FLINT HILLS AREA TRANSPORTATION AGENCY

Procurement Type: Invitation to Bid
Procurement ID: FY22-1004 Bus Shelter Projects

ADDENDUM 2: Response to Vendor Questions

The Bench Component

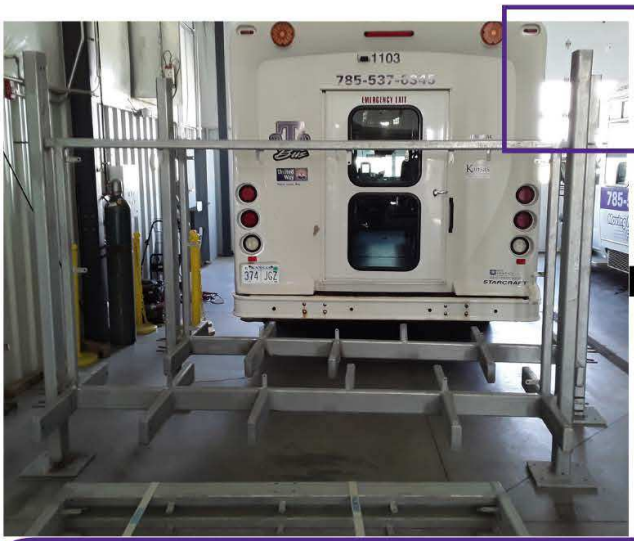
The canopy component would slide into the top and be secured using holes here

Hole placement on inside and outside of posts

Additional Photos

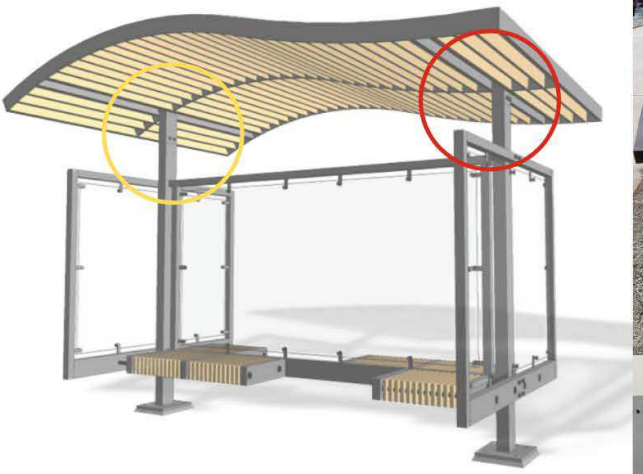
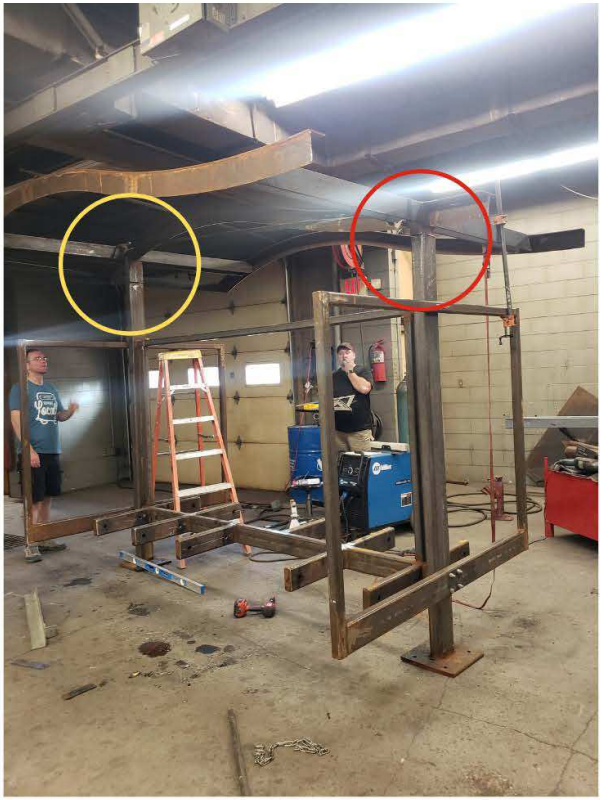
1 of 2 posts that slide into the top of the bench component, hole is open allowing for positioning with bench component holes

Extra material was added to bottom of canopy post for stability
